# Access Compliance Report

## Public Rights-of-Way

### (Curb Ramps)

Intersection ID: 10033070	Main Street: NORTH_COMMUNITY_HOUSE_RD	Cross Street: N/A	Location: SE
ADA ID: 504E102B8398	Ramp Type: Perp	Initial Pass/Fail: Pass	Overall Compliance: No
			Severity Score: 0

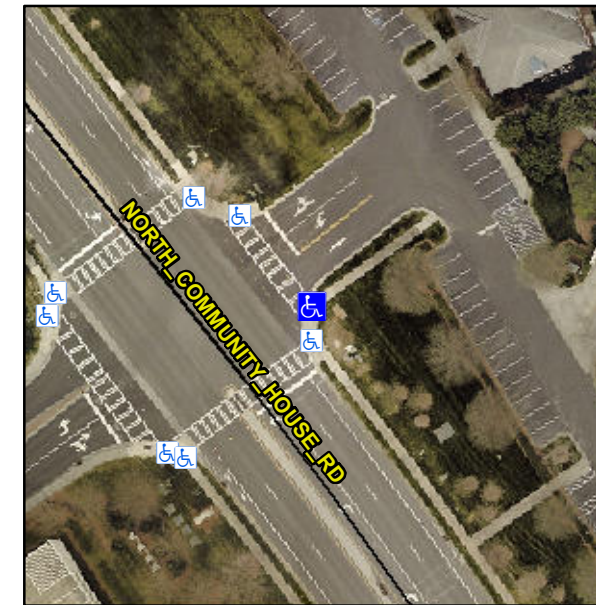
**Not Found, R304.2.1, R305.2**

**Remove & Replace Entire Ramp.**
